Objection submission COM/2019/81 -

Extractive Industry Development Code - 9.3.8 -

'Extractive Industry' development code requirements

Attachment F2 - Contour diagram (Derived from City Plan) of western edge of proposed quarry footprint as viewed from the roads adjoining

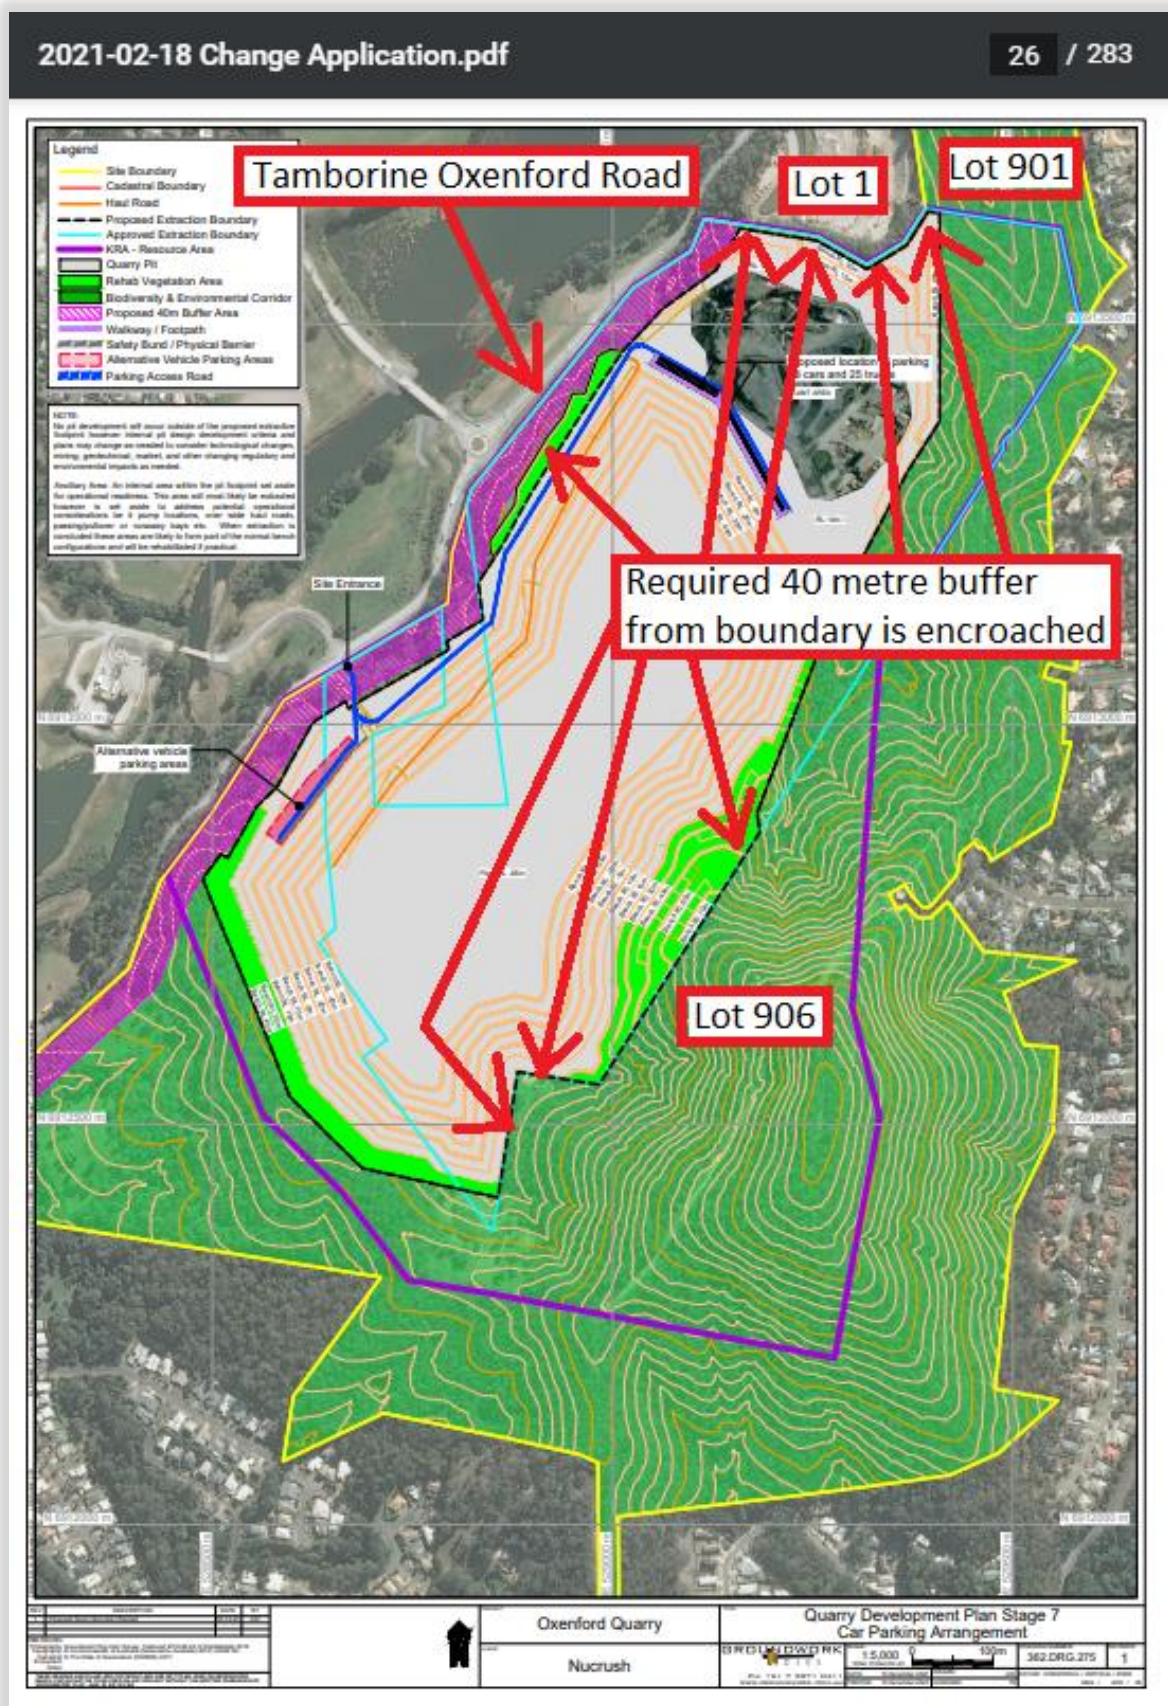
It is interesting, if not somewhat alarming, to view the contour diagram of the area between the major Tamborine Oxenford Road and the Maudsland Road and the proposed quarry. This has been, I believe, reproduced to scale in Attachment F2. From this it can be clearly seen that for at least a 150m stretch there will be no physical boundary protecting views straight into the quarry from the Maudsland Road. This is obviously contra to the clear requirements of *'Acceptable Outcome AO3.2'* which states: *"Views of significant infrastructure and visually obtrusive development including quarry floors, benches and faces, are screened from the road frontage, major road corridors and adjoining residential areas"* (Attachment A1).

Attachment F3 - 'Plan 362-010' or 'Third Schedule' of Rezoning Agreement (colour coded with "Extractive Industry Area" Lot 467) highlighted

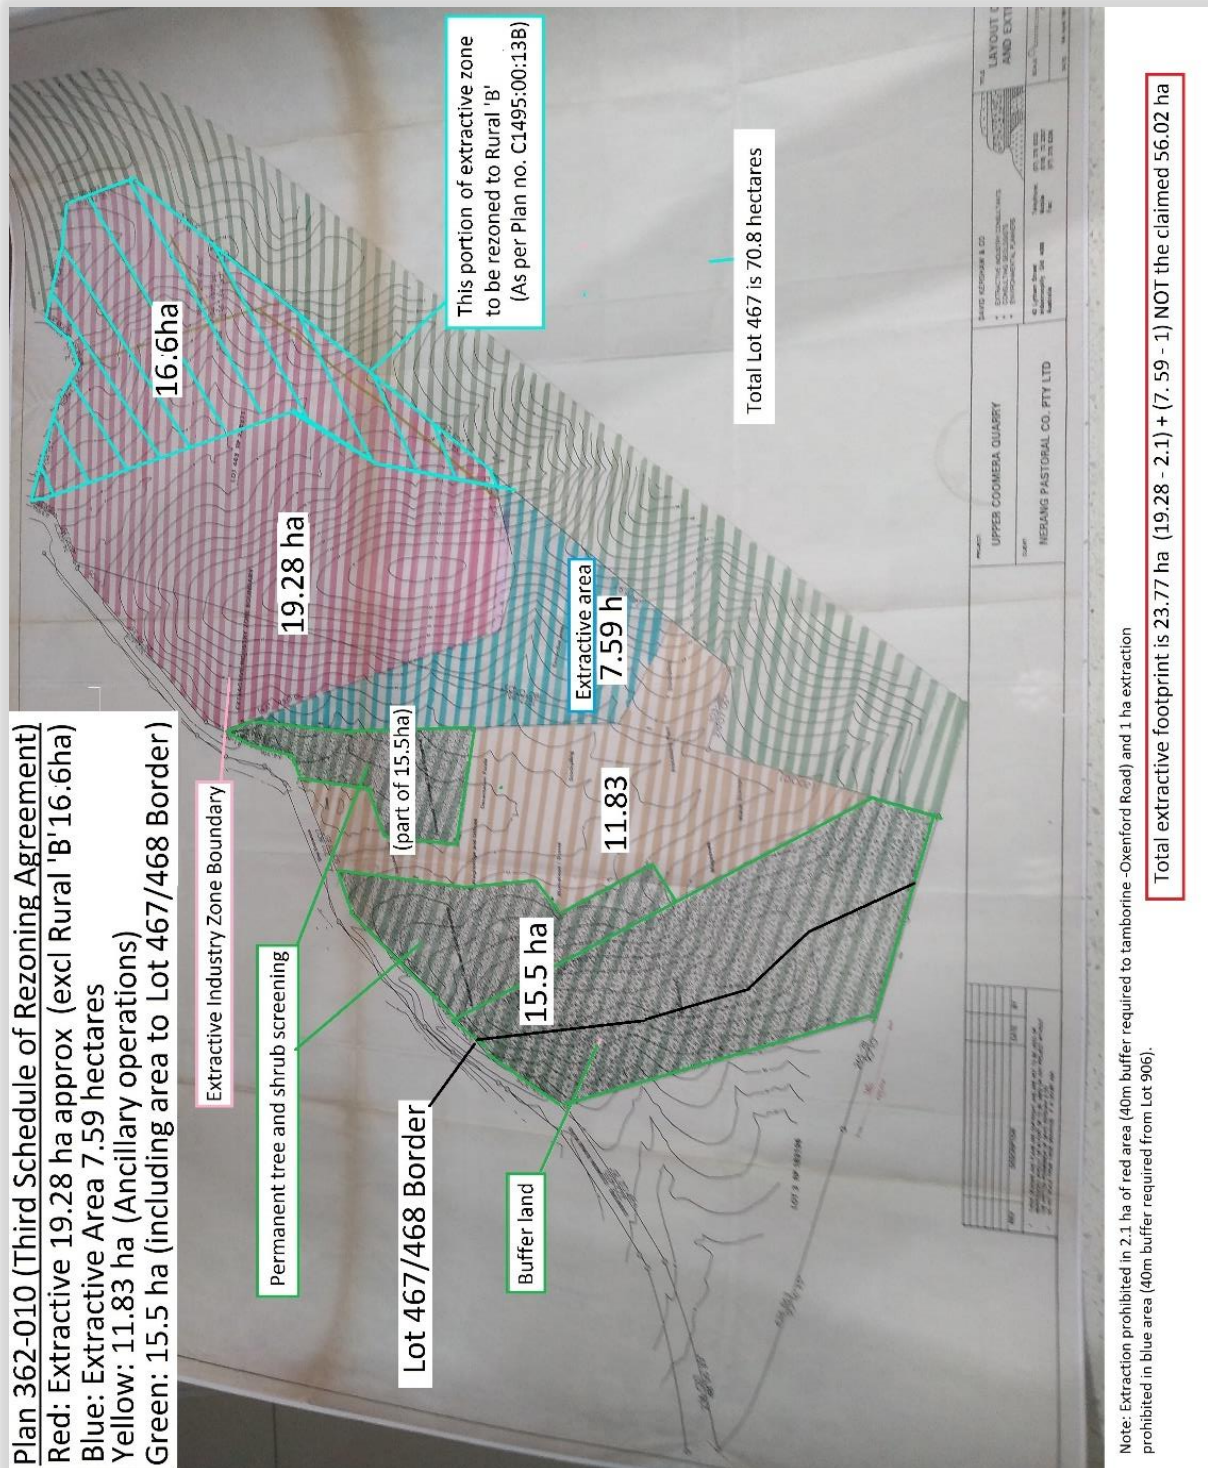
The *'Third Schedule'*, or *'Plan 362-010'* (annotated version reproduced in attachment F3), within the original rezoning agreement (part of the *'Current Approval'*) was, I believe, culpably removed from the development application's submitted copy of the rezoning agreement (included as part of the DA in: *'The Main application'*, page 290-328 inclusive).

This, as I see it, culpable omission of important and relevant information, has I believe led the applicant to claim the current approved footprint is 56.02 ha (Attachment F4) when it would seem it is in fact more like 23.77 hectares approx (as shown in attachment F3).

correctly reproduced in the *'Third Schedule'* (Plan 362-010) of the original rezoning agreement Attachment F3 (without the necessary 40 metre boundaries shown).
